Product / Process Change Notification (PCN)

PCN #: PCN_UtRJ45LAN_20200916

Affected Series: WE-RJ45LAN; 7498xxx, Sxxx

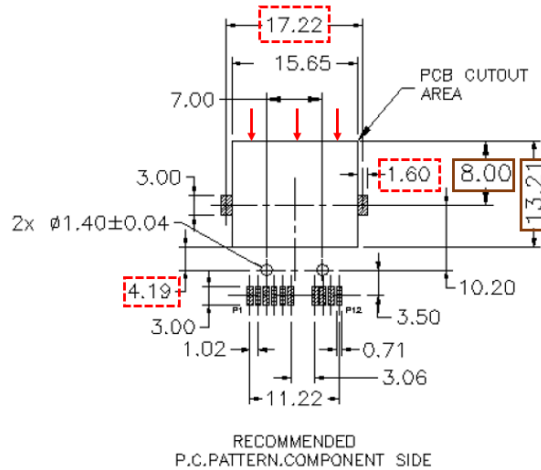
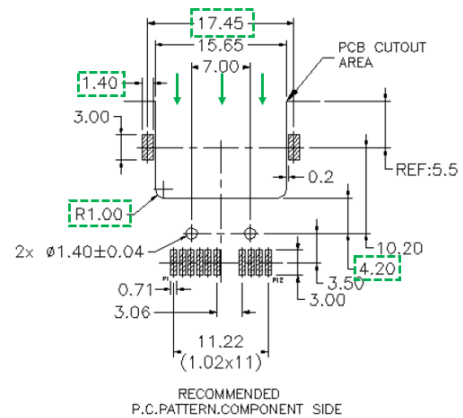
As a datasheet information amendment and correction, Würth Elektronik will add additional parameters and correct the recommended land pattern. Due to this correction some dimensions and tolerances in the drawing will be adjusted.

Some PCB cut-off dimensions are incorrect and will be removed (brown mark).

Compared to the old drawing (see red mark), the new cut-off is open at the top side and the EMI pad positions will be slightly adjusted (green mark).
